Eliza Yard – Jersey Street Ancoats
Design and Access Addendum
February 2024

13.02.24

Introduction

EXISTING ACTIVE FRONTAGES

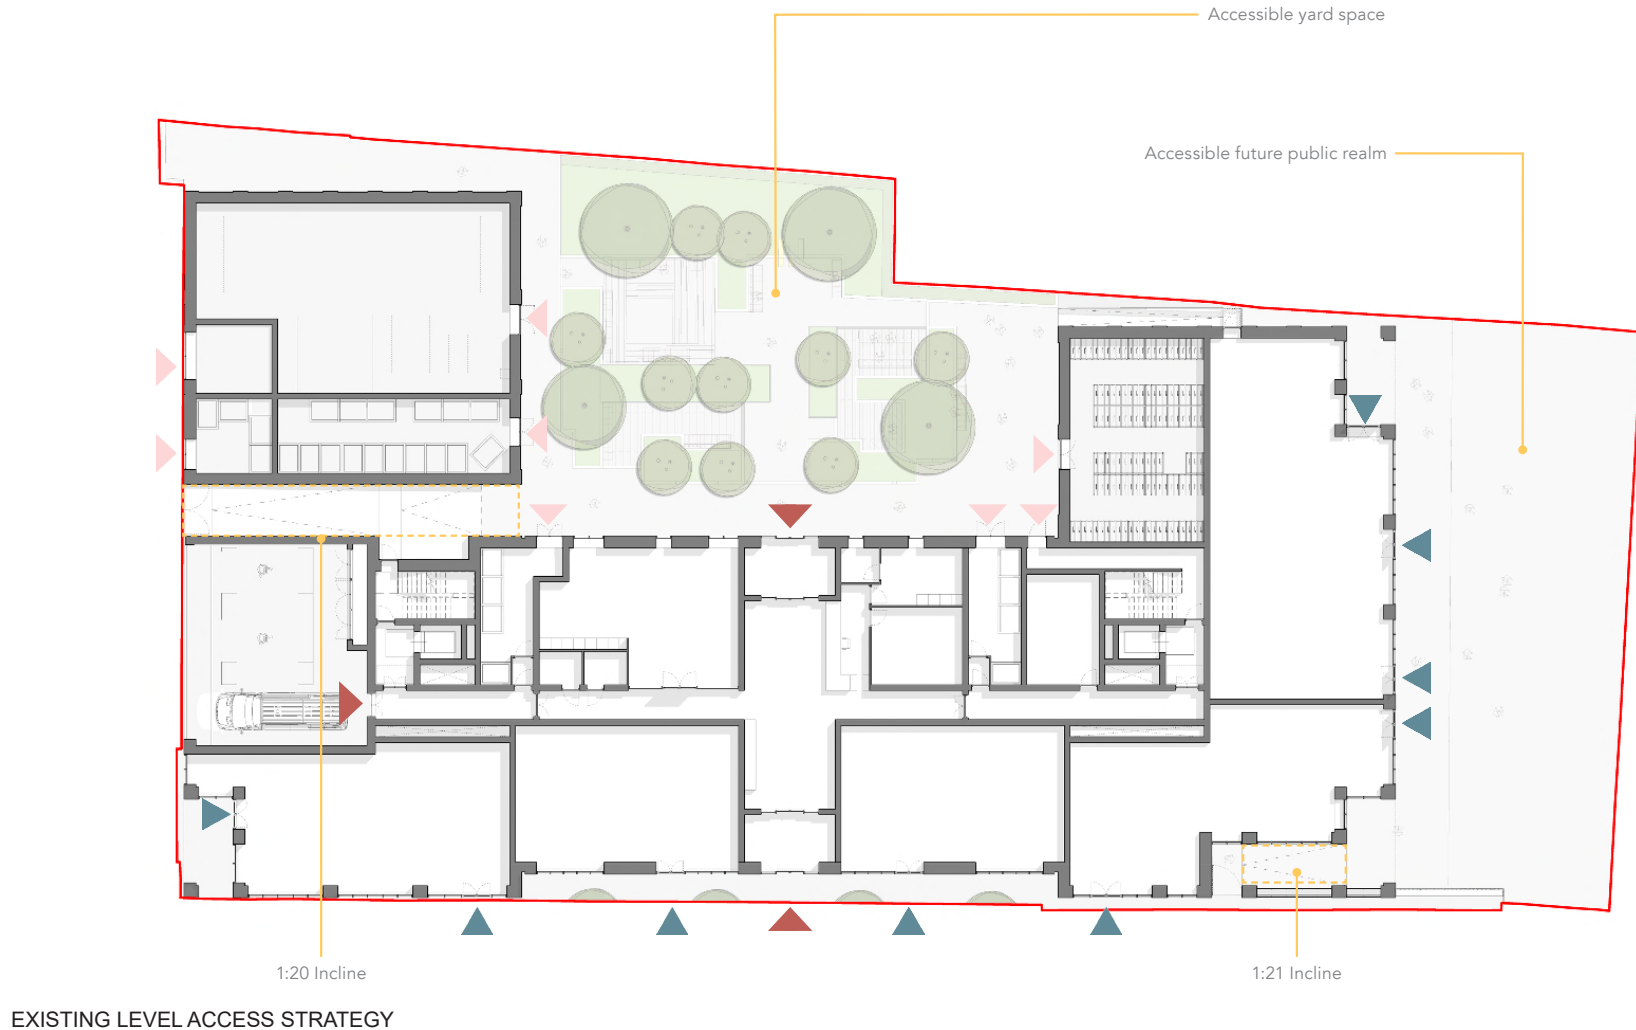
The newly added apartments at Ground Floor will provide good surveillance to the future green link and public realm, known as the Prussia Street Arm Greenway - Planning reference: 136141/VO/2023. The apartments here will also be provided with front doors onto this space, defined with an area of defensible space of patio and hedging. This will contribute to the future use of this corridor space and activity along it.
